**Bradley Hills 1<sup>st</sup> Addition to Section 2, Preliminary Plan, 120140160**

Staff Report Date: 1/30/15

**RECOMMENDATION:** Approval of Bradley Hills 1<sup>st</sup> Addition to Section 2, Preliminary Plan No. 120140160, subject to the following conditions:

RE: Preliminary Plan No. 120140160  
Bradley Hills, 1<sup>st</sup> Addition to Section 2

*Variance Request Trees to be Removed or Impacted*

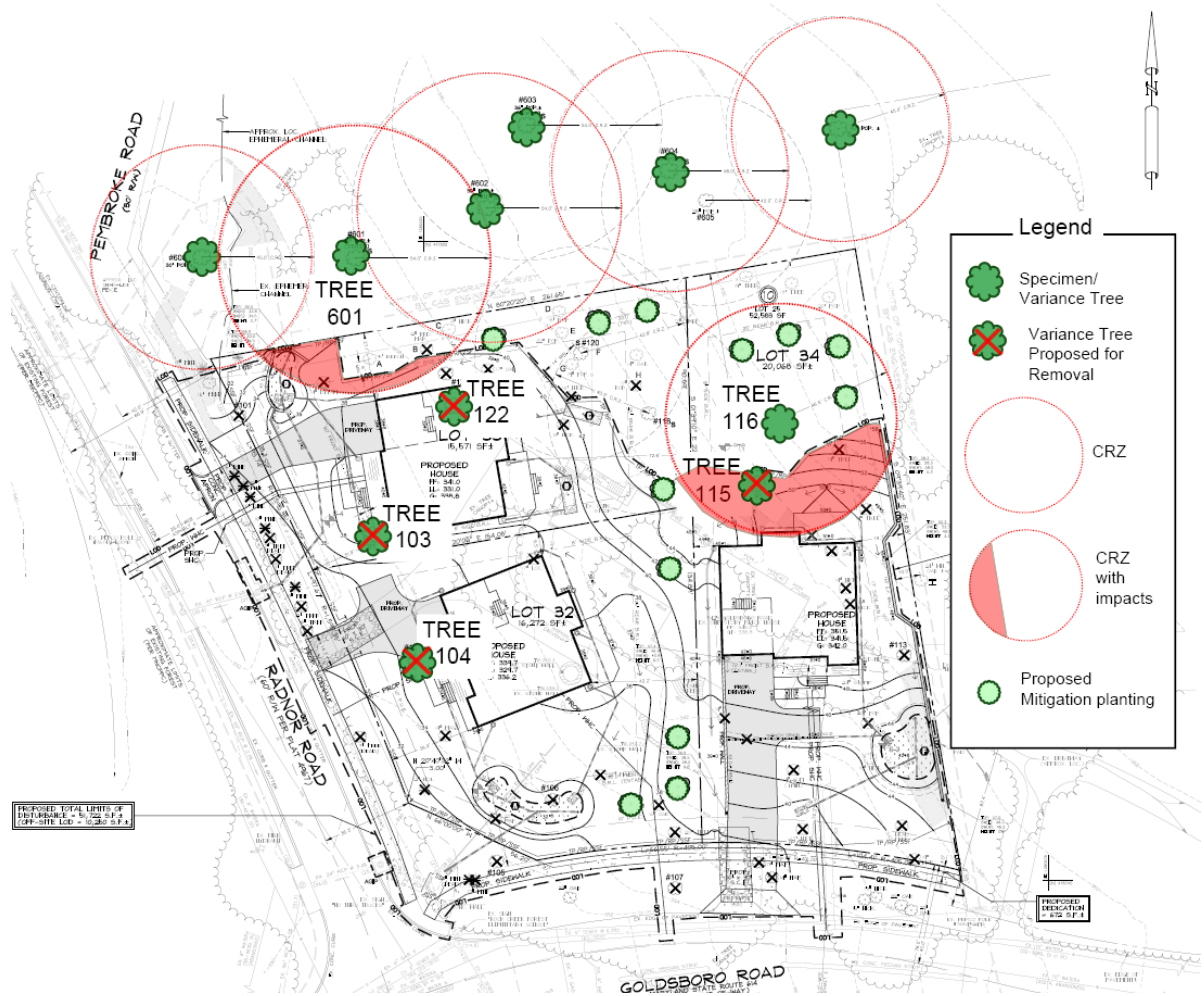
The Application proposes to remove four specimen trees, ranging in size from 32" to 39.5" DBH, that are subject to a Forest Conservation Variance. The trees to be removed and the proposed redevelopment of the site are discussed below in further detail.

Section 22A-12(b)(3) of Montgomery County Forest Conservation Law provides criteria that identify certain individual trees as high priority for retention and protection. Any impact to these trees, including removal of the subject tree or disturbance within the tree's critical root zone (CRZ), requires a variance. An Applicant for a variance must provide certain written information in support of the required findings in accordance with Section 22A-21 of the County Forest Conservation Law. The law requires no impact to trees that: measure 30 inches DBH or greater; are part of a historic site or designated with a historic structure; are designated as national, state, or county champion trees; are at least 75 percent of the diameter of the current State champion tree of that species; or to trees, shrubs, or plants that are designated as Federal or State rare, threatened, or endangered species. The proposed project includes disturbance within the CRZ of trees which are subject to a variance due to their size measuring 30 inches DBH or greater. The Applicant submitted the variance request package on December 2, 2014, for the impacts and removals of subject trees. The Applicant's request is to remove four trees and impact, but not remove, two trees are that are considered high priority for retention under Section 22A-12(b) (3) of the County Forest Conservation Law. Attachment C includes the Applicant's variance request.

There are four subject trees proposed for removal in association with the project. There will also be some disturbance to CRZs of another two subject trees that will be retained. Planting mitigation for the removals should be at a rate that approximates the form and function of the trees removed. Therefore, staff is recommending that replacement occur at a ratio of approximately 1" DBH for every 4" DBH removed, using trees that are a minimum of 3" DBH. This means that for the 141 diameter inches of trees to be removed, the Applicant should provide mitigation of 36 inches of caliper

Staff recommends the Planning Board approve the Applicant's request for a variance from Forest Conservation Law to remove four trees and impact, but retain, two subject trees associated with the site. The variance approval is assumed into the Planning Board's approval of the Forest Conservation Plan.
